PLANNING COMMISSION RESOLUTION NO. 96-51

**DEPARTMENT OF COMMUNITY DEVELOPMENT
STAFF REPORT
TO THE CITY OF MILL CREEK PLANNING COMMISSION**

CITY FILE NO. Preliminary Plat No. 95-46 - The Parks at Mill Creek, Division VII

TYPICAL 40' ROAD SECTION

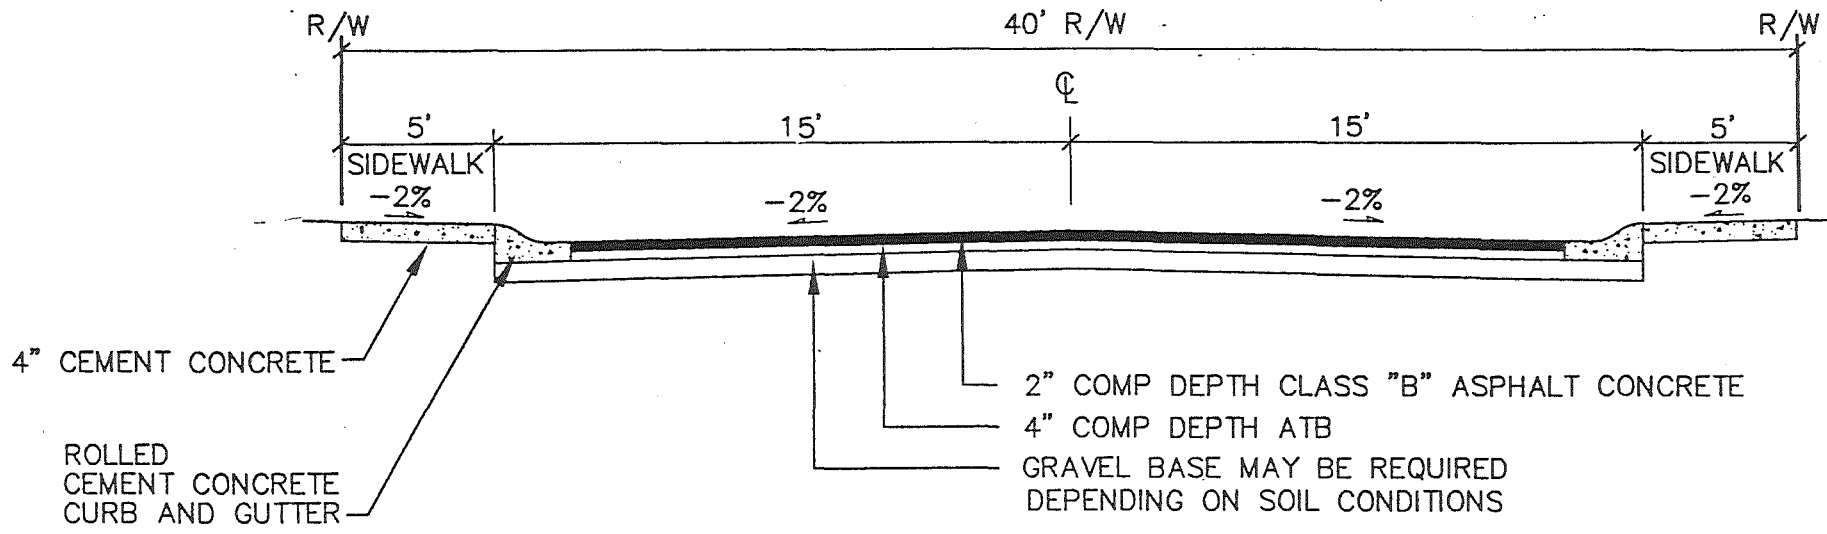
Planting Strips: The applicant is proposing a 40-foot right-of-way width for the interior cul-de-sac streets within the plat with sidewalks adjacent to the curbs (see the applicant's proposed street cross sections included in the staff report as **Attachment 2**). Previous divisions of The Parks at Mill Creek have required that five-foot planting strips be located between the sidewalk and the curb. Locating a planting strip between the curb and sidewalk results in an aesthetically pleasing streetscape. Consistent with previous requirements within The Parks at Mill Creek, as well as throughout the City, staff is recommending that planting strips be required between the curb and sidewalk, and that if the sidewalk needs to be located outside the right-of-way on individual lots, that a public access pedestrian easement be placed on the sidewalks. This recommendation is included in the suggested conditions of approval.

Another related issue is the design of the 40-foot road section for the interior streets within the plat. As discussed above under Streetscape, staff is recommending that the sidewalks be separated

from the street with a five-foot wide planting strip. This would result in the sidewalks being placed outside the right-of-way on individual lots, with public access easements for pedestrian use. If this recommendation is adopted by the Planning Commission, staff suggests that the garage setback be measured from the edge of the sidewalk closest to the garage in lieu of the right-of-way as proposed by the applicant. This would ensure that the purpose of the setback would be achieved.

10. Standard sidewalks separated from the curb by a five-foot wide planting strip are required on both sides of the public streets within the plat. Sidewalks located outside the right-of-way shall be subject to a public pedestrian access easement allowing public access to said sidewalk facilities.

10. Standard sidewalks, separated from the curb by a four-foot wide planting strip, are required on both sides of the public streets within the plat. Sidewalks located outside the right-of-way shall be subject to a public pedestrian access easement allowing public access to said sidewalk facilities.
